**Subject:** 54 Bardo Road Newport 2106 DA 2020/1172 WRITTEN SUBMISSION:  
LETTER OF OBJECTION Submission: Beggs

Re:  
54 Bardo Road Newport 2106  
DA 2020/1172

WRITTEN SUBMISSION: LETTER OF OBJECTION  
Submission: Beggs

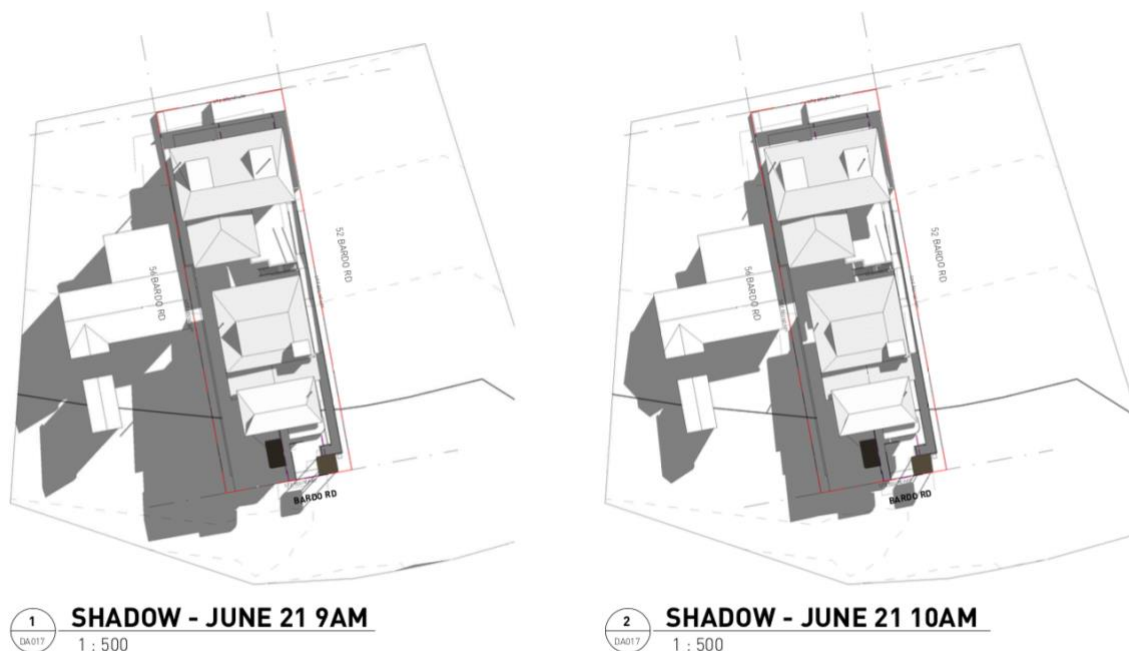
This is a major concern for us, as our property lies to the west of the subject site, and therefore has the greatest impact to solar loss in the morning.

The shadow diagrams show considerable morning solar loss to the eastern windows between 9am and 12 noon.
